dsPIC33EPXXGS50X Family Silicon Errata and Data Sheet Clarification

The dsPIC33EPXXGS50X family devices that you have received conform functionally to the current Device Data Sheet (DS70005127C), except for the anomalies described in this document.

The following typographic corrections and clarifications are to be noted for the latest version of the device data sheet (DS70005127C):

FIGURE 1: EXAMPLE FOR REDUNDANT OUTPUT MODE

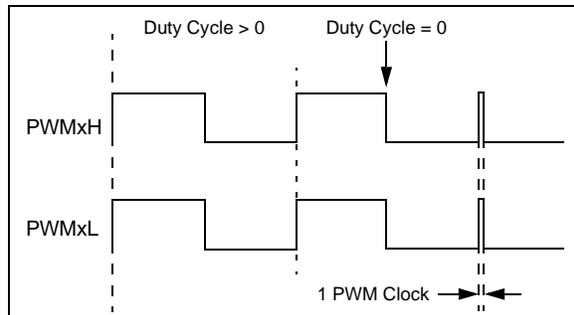
In the Redundant Output mode (IOCONx<11:10> = 0b01) and Push-Pull Output mode (IOCONx<11:10> = 0b10), with the Immediate Update Enable bit disabled (PWMCONx<0> = 0), when the Duty Cycle register is updated from a non-zero value to zero, a glitch pulse of a width equal to 1 PWM clock will appear at the next PWM period boundary, as shown in Figure 1 (for the Redundant Output mode). The Duty Cycle register refers to the PDCx register if PWMCONx<8> = 0 or the MDC register if PWMCONx<8> = 1.

If the application requires a zero duty cycle output, there are two possible work around methods:

1. Use the PWM override feature to override the PWM output to a low state instead of writing to the Duty Cycle register. In order to switch back to a non-zero duty cycle output, turn off the PWM override. The override-on and override-off events must be timed close to the PWM period boundary if the IOCONx register has been configured with IOCONx<0> = 0 (i.e., output overrides through the OVDDAT<1:0> bits occur on the next CPU clock boundary).
2. Enable the Immediate Update Enable bit (PWMCONx<0> = 1) while configuring the PWMx module (i.e., before enabling the PWMx module, PTCON<15> = 1). With the Immediate Update enabled, writes to the Duty Cycle register can have an immediate effect on the PWM output. Therefore, the duty cycle write operations must be timed close to the PWM period boundary in order to avoid distortions in the PWM output.

FIGURE 2:

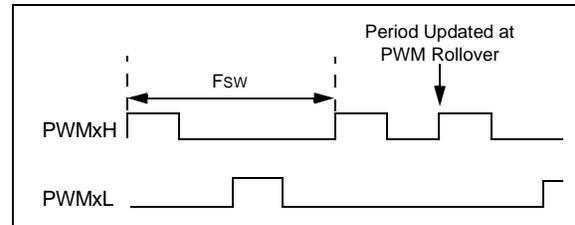
When the PWM module is configured for Push-Pull mode (IOCONx<11:10> = 0b10) with the Enable Immediate Period Update bit enabled (PTCON <10> = 1), a write to the Period register that coincides with the period rollover event may cause the push-pull output logic to produce back-to-back pulses on the PWMx pins (Figure 2).

Ensure that the update to the PWM Period register occurs away from the PWM rollover event by setting the EIPU bit (PTCON<10> = 1). Use either the PWM Special Event Trigger (SEVTCMP) or the PWM Primary Trigger (TRIGx) to generate a PWM Interrupt Service Routine (ISR) near the start of the PWM cycle. This ISR will ensure that period writes do not occur near the PWM period rollover event.

FIGURE 3: MISMATCH OF WORKING REGISTER SET WHEN NESTING MORE THAN ONE INTERRUPT WITHIN INTERRUPTS THAT USE ALTERNATE WORKING REGISTER SETS

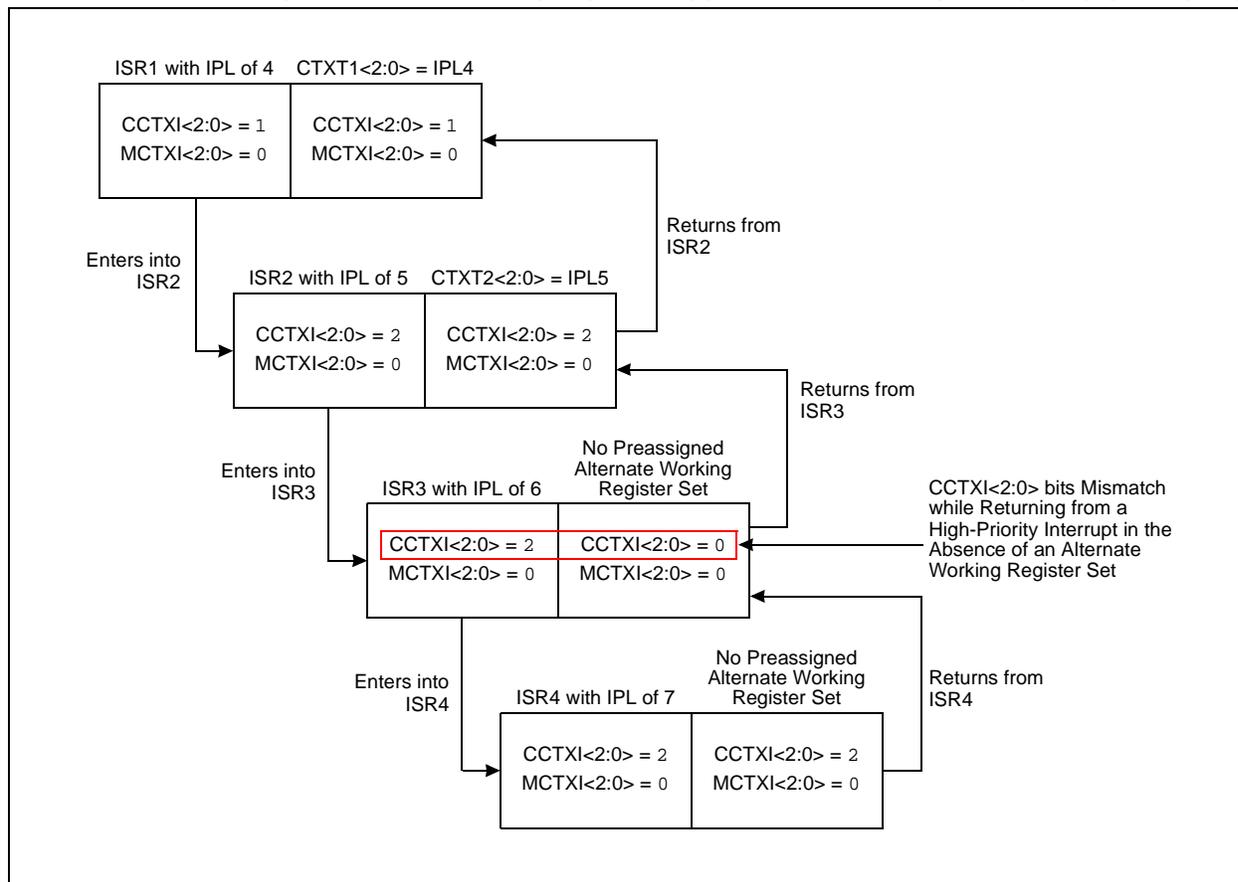
When returning from an Interrupt Service Routine (ISR) by executing the `RETFIE` instruction, in the case of a nested interrupt, the Interrupt Priority Control bits (`IPC<3:0>`) associated with the lower priority interrupt are compared with the `CTXTn` bits field in the `FLTREG` Configuration register:

When using interrupts with the Alternate Working Register Set (automatic context assignment), no more than one ISR without an Alternate Working Register Set must be nested within an ISR with an Alternate Working Register Set.

Issue and work around are illustrated in [Figure 3](#) and [Figure 4](#), respectively. The figures show the status bits, `CCTXI<2:0>` and `MCTXI<2:0>`, after entering into an ISR from a lower priority ISR (left pane), and after returning to the same ISR from a higher priority ISR (right pane).

48-Lead Thin Quad Flatpack (Y8) - 7x7x1.0 mm Body [TQFP]

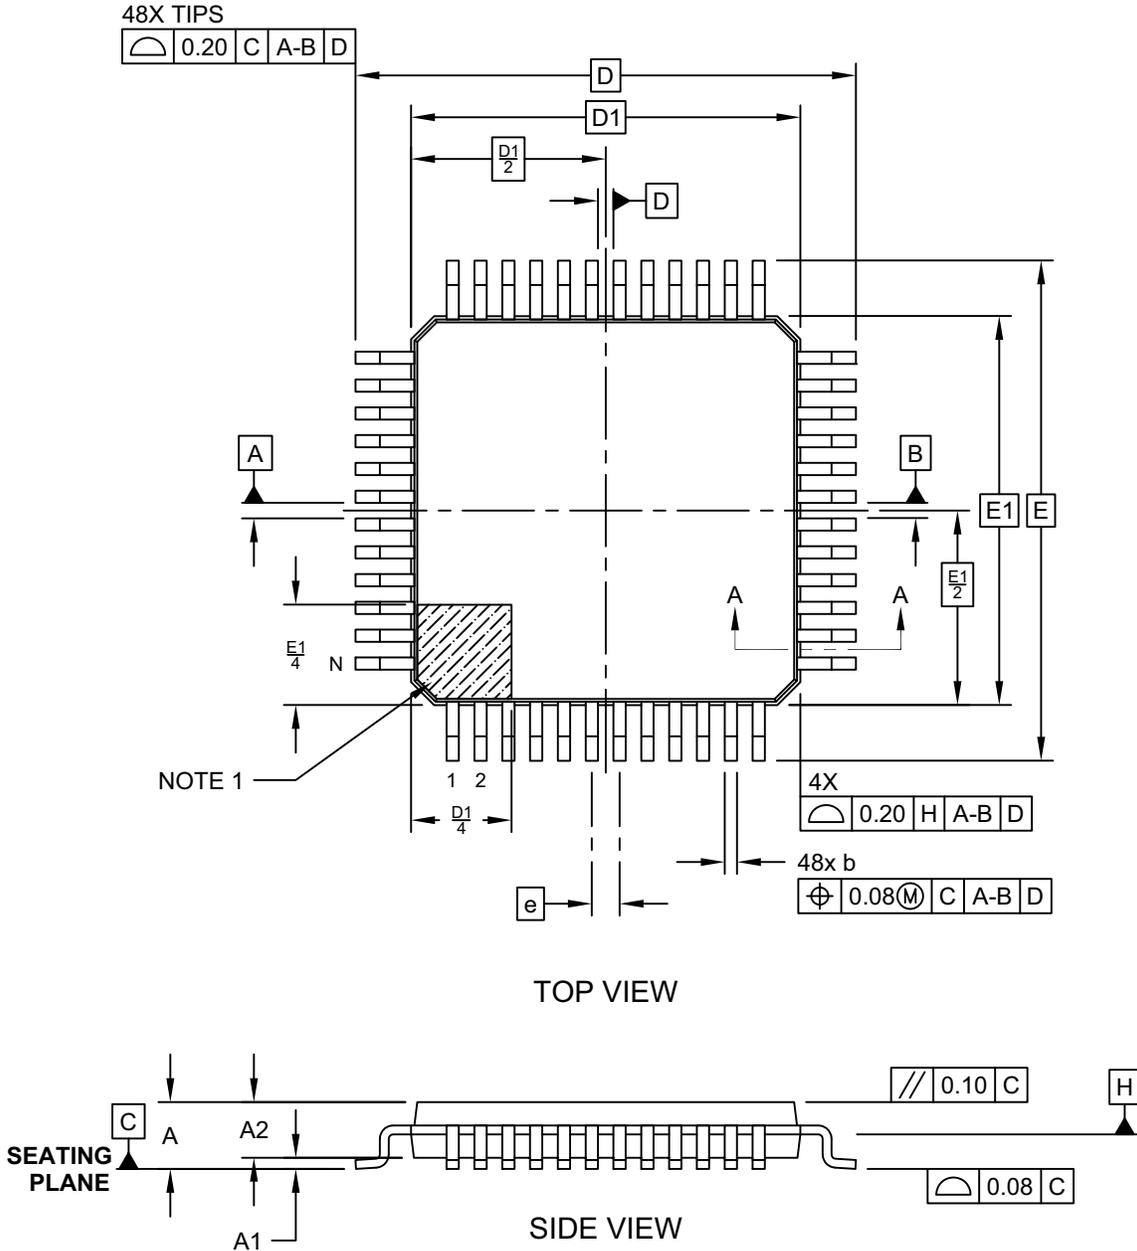
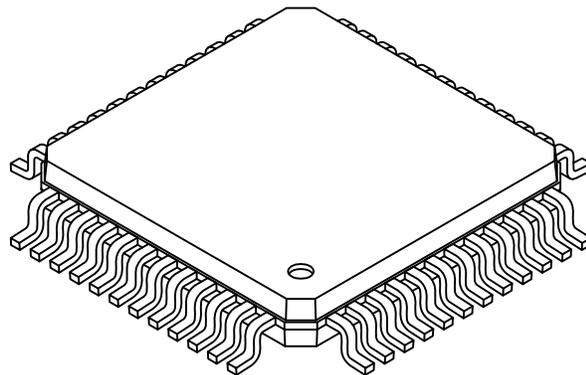
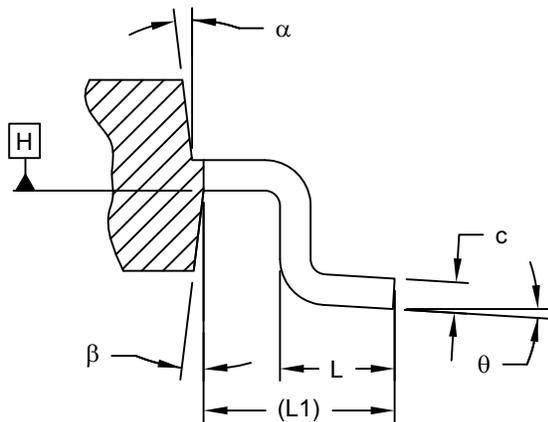
In the “*dsPIC33EPXXGS50X Family Data Sheet*”, **Section 28.2 “Package Details”**, dimensions for the 48-Lead Thin Quad Flatpack (PT) - 7x7x1.0 mm Body [TQFP] With Exposed Pad is mentioned. However, the dsPIC33EPXXGS50X family devices are not available in this package with the exposed pad.

The dsPIC33EPXXGS50X family devices are available in the 48-Lead Thin Quad Flatpack (Y8) - 7x7x1.0 mm Body [TQFP] without Exposed Pad and the package dimensions are shown on the following drawings.

Dimension Limits	Units	MILLIMETERS		
		MIN	NOM	MAX
Number of Leads	N	48		
Lead Pitch	e	0.50 BSC		
Overall Height	A	-	-	1.20
Standoff	A1	0.05	-	0.15
Molded Package Thickness	A2	0.95	1.00	1.05
Foot Length	L	0.45	0.60	0.75
Footprint	L1	1.00 REF		
Foot Angle	ϕ	0°	3.5°	7°
Overall Width	E	9.00 BSC		
Overall Length	D	9.00 BSC		
Molded Package Width	E1	7.00 BSC		
Molded Package Length	D1	7.00 BSC		
Lead Thickness	c	0.09	-	0.16
Lead Width	b	0.17	0.22	0.27
Mold Draft Angle Top	α	11°	12°	13°
Mold Draft Angle Bottom	β	11°	12°	13°
